Reply to the Referee Comment by Anonymous Referee #1

Gao et al. present a very impressive study that investigates how changing climate conditions influence hydrologic processes in a cold environment (particularly the Heihe basin in the Qinghai-Tibetan Plateau). Their model enhancements include algorithms for considering frozen ground processes. As such, they address how the hydrologic system responds to forcing (changing precipitation) but also to the changing system characteristics themselves (i.e. type and distribution of frozen ground). This study certainly has merit for publication in TC and has potential to be an important paper in this field. There are a few issues that I think should be considered prior to publication. Most of these are relatively minor, but addressing them all will likely warrant a major revision.

(a) Model structure

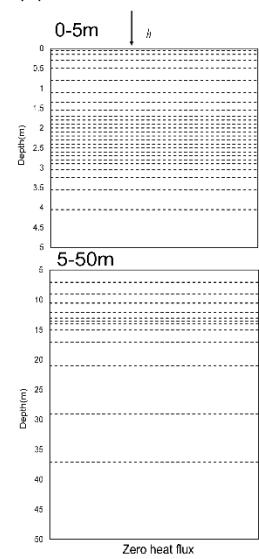
6. The authors would do well to include a figure of their modeling domain – at least their vertical discretization and boundary conditions. I find this lacking.

Reply: Thank you for this suggestion, we have added a figure ([the following figure](#)) to

show the model structure, vertical discretization and boundary conditions.

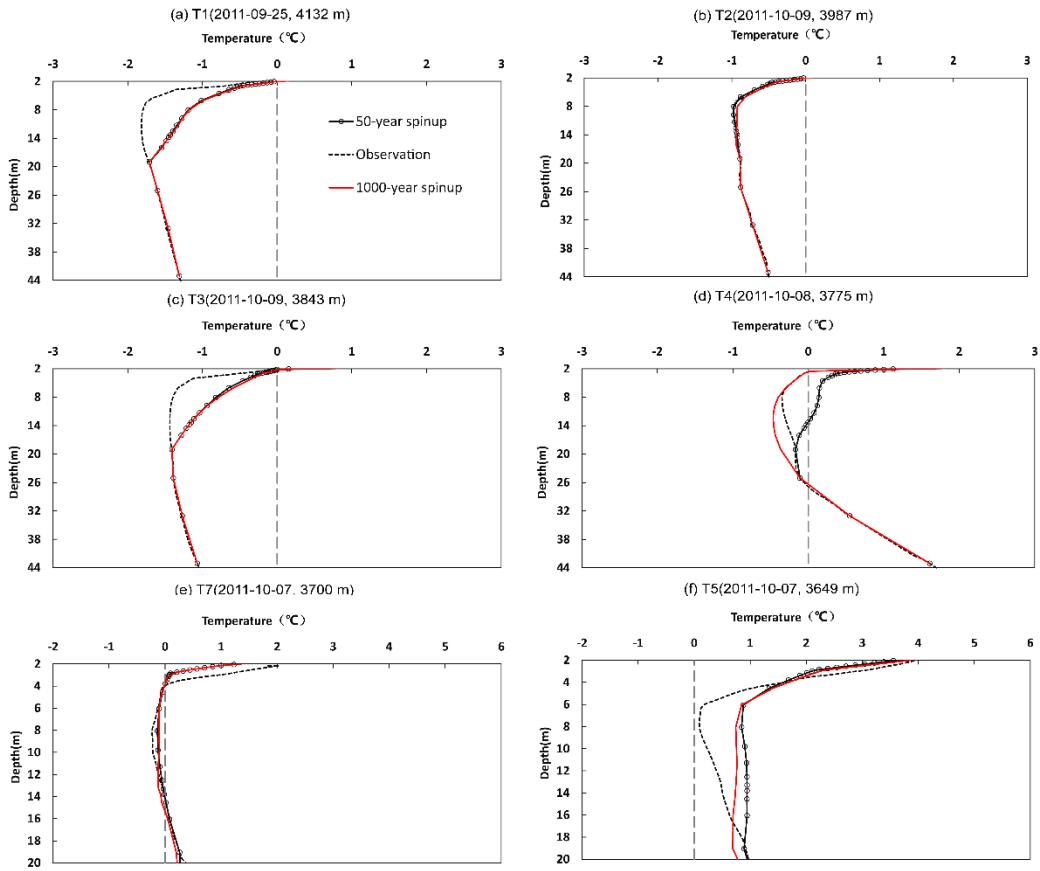
8. I'm confused at how the authors formed permafrost in 50 year spin up run (e.g. L297 and elsewhere). I've modeled even thin permafrost using 1000 year spin ups. Can the authors please describe this better? I wonder if this lack of permafrost formation time might partially cause some of the poor fits seen in Figure 2. Related to this, I wonder if the fits in Figure 2 in the shallow zone would look better at another time in the year (which the authors likely don't have data for). In other words, it could be the seasonal dynamics that are off, not the multi-decadal dynamics.

Reply: GBEHM saves the status variables (e.g., soil moisture, soil temperature, soil ice content, groundwater table, etc.) during the model calibration. The 50 year spin up run used the saved values as the initial conditions. So the actual spin up run was more than 50 years. We also carried out a 1000 year spin up run and compared the difference from the previous result (shown in the following figure). We found that the soil temperature is not so sensitive to the spin up time. It may be because that permafrost is shallow in the upper Heihe basin.

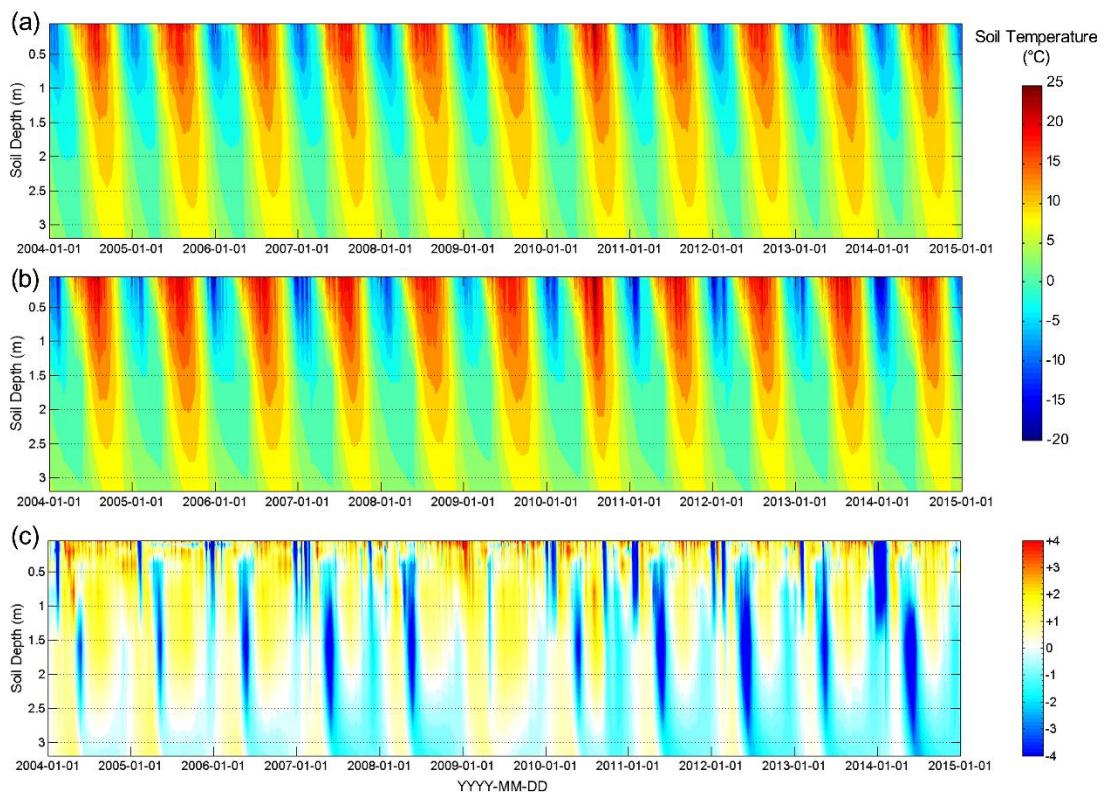
9. L330 and surrounding text, the authors suggest that RMSE decreases with increasing depth in Figure 3. It looks to me however (somewhat counter to what intuition would suggest) that the errors are increasing with depth (simulation – observation in Figure 3c goes to dark blue at the bottom indicating higher error and is white, indicating low error, higher up).

Reply: Thank you very much for this comments. We checked the calculation of RMSE and the plot of Figure 3c. It is confirmed that RMSE decreased with increasing depths though we have made small mistakes in calculation of RMSE for some depths. The problem is due to the coarse resolution of the color bar and errors for interpolation of the shaded counter in Figure 3c. We have also updated Figure 3c as follow.
